**CITY OF SAINT PAUL
HERITAGE PRESERVATION COMMISSION STAFF REPORT**

FILE NAME: 535 Dayton Avenue
DATE OF APPLICATION: October 2, 2015
APPLICANT: Josh Hanson, JJH Homes Corp
OWNER: Anastasios & Carey Pappas
DATE OF PUBLIC HEARING: October 22, 2015
HPC SITE/DISTRICT: Hill Historic District
CATEGORY: New Construction
CLASSIFICATION: Building Permit
STAFF INVESTIGATION AND REPORT: Bill Dermody
DATE: October 12, 2015

FRONT ELEVATION

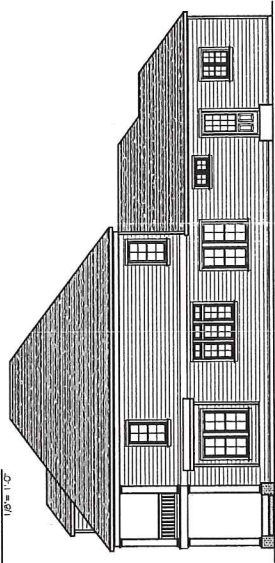
9. Building Elements: Doors and Windows. The doors and windows on the front elevation are compatible in *proportion, size and rhythm with that of existing adjacent buildings*. The guidelines state "*Wooden double-hung windows are traditional in the Historic Hill District and should be the first choice when selecting new windows.*" The proposed windows are Marvin Integrity series which have a thinner profile than that of a historic wood sash, and would not be appropriate for installation in a historic building, but should be suitable for this new construction proposal. The square and horizontally oriented windows do not follow the traditional vertical emphasis of the Hill Historic district, but individually and grouped relate to historic piano windows and comply with the guideline which states that *individual windows can sometimes be square or horizontal if the rest of the building conveys the appropriate directional emphasis*.

10. Materials and details were not provided for the doors. The front door is $\frac{3}{4}$ lite with divided panes and sidelights, which is appropriate for the style and proportion of the new construction. A final door and window schedule as well as materials scheduled will need to be submitted to determine full compliance with the guidelines.

11. Building Elements: Porches and Decks. The proposed full-width, two-story open front porch is compatible with the established rhythm of one- and two-story full-front open porches nearby. The open *porch treatment relates to the porch treatment of existing adjacent structures*, which are mostly open and have columns supporting the roof. The columns visually carry the weight of the porch to grade, and they do not interrupt the horizontal line of the porch floor which is a traditional detail. Final porch materials and details such as flooring, skirting, treads, risers, and balustrade still need to be provided and reviewed to determine full compliance with the guidelines. The whole porch is raised and at an elevation that appears to be consistent with its neighbors. The 2nd story balustrade is simple in design.

1. The stair treads and risers at the front porch shall be solid wood. Any handrails shall be submitted to staff for review and approval.
2. All CMU block used above grade on the house and garage shall be rock-faced or split-faced, and in a limestone color.

3. A final door and window schedule shall be submitted to HPC staff for final review and approval. The front door shall be wood. All divided lights shall be simulated or true divided.

BASEMENT PLAN
 25' 0" x 36' 0"

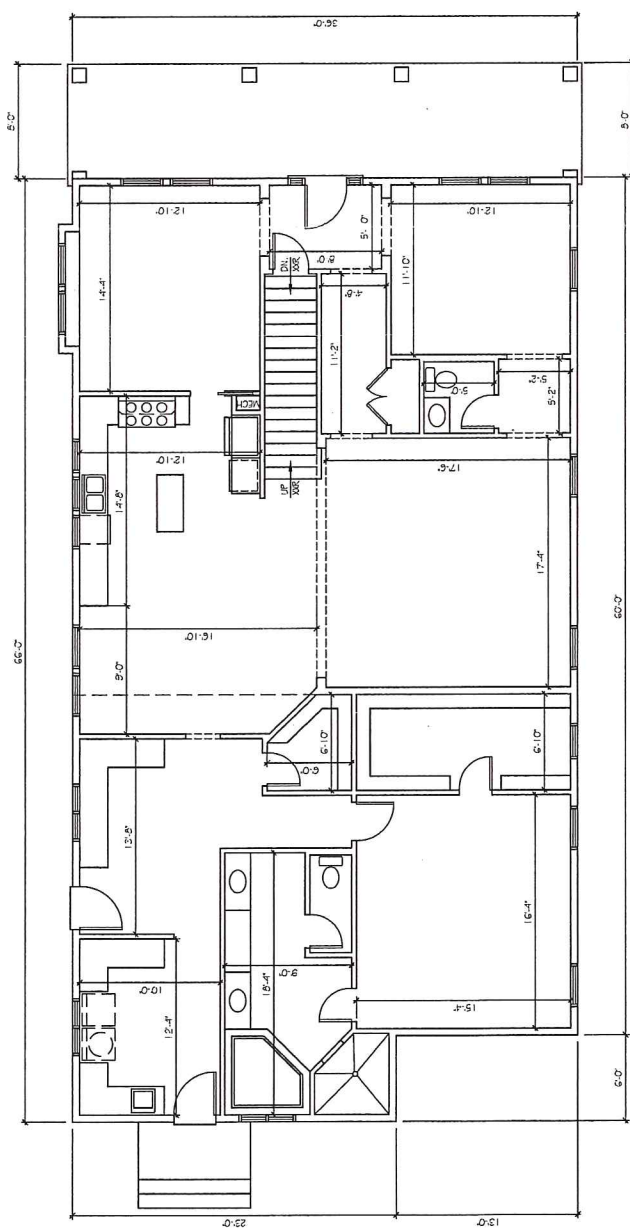
Basement windows were not shown on the elevations, but are on the basement plan. There are individual windows on the west side elevation. Final window details and any egress wells will need to be reviewed and approved.
